# CITY OF PORTLAND, MAINE

**Project Name:** 510 Stevens Avenue  
**Address:** 510 Stevens Avenue  
**Applicant:** 510 Stevens Avenue, LLC  
**Planner:** Matthew Grooms

On March 13, 2018, the Planning Board considered a Level III Site Plan and Subdivision application for a new three-story mixed-use commercial and residential building with 3 townhouse-style apartment units, 1,095 square feet of commercial space and eight off-street parking spaces. The Planning Board reviewed the proposal for conformance with the standards of the Site Plan and Subdivision ordinance. The Planning Board voted 7-0 to approve the application with the following waivers and conditions as presented below:

RE: Staff Review Comments for 510 Stevens Avenue – Mixed-Use Commercial Residential Project (2017-283) – Planning Board Review

Figure 3: Proposed site plan with shared access driveway

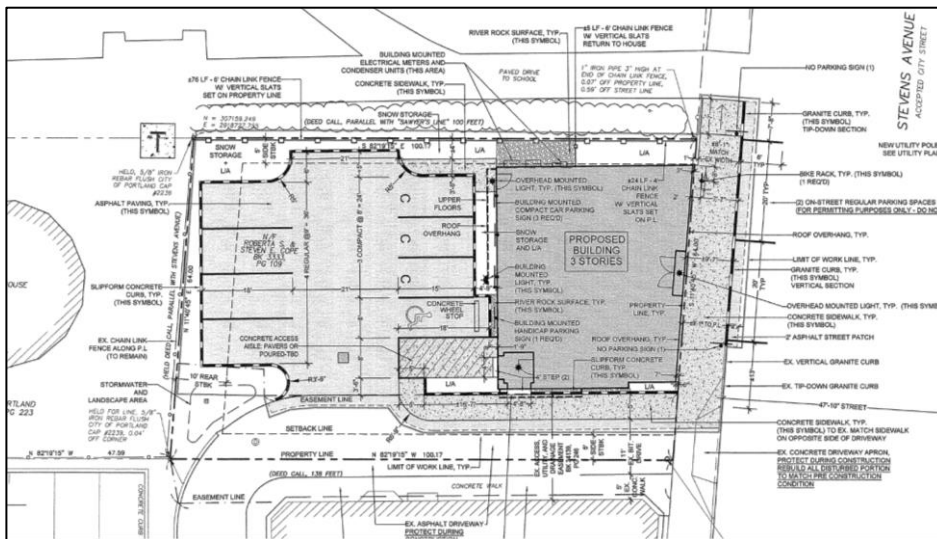
The proposed parking layout features a drive aisle width of twenty-one (21) feet, which is less than the city's standard for two-way driveways, twenty-four (24) feet. In reviewing the applicant's waiver request, the city's consulting traffic engineer offered the following comment ([Attachment 2](#)):

1. The Planning Board voted 7-0 to waive the Technical Standard (Section 1.14, Figure I-27) which requires that a two-way driveway aisle for right-angle parking be twenty-four (24) feet in width, to allow a driveway aisle width of twenty-one (21) feet.
2. The Planning Board voted 7-0 to waive the Technical Standard (Section 1.14) which requires that parking lots of 10 or fewer parking spaces contain only standard sized parking spaces, to allow three (3) compact parking spaces, comprising 37.5% of total parking.
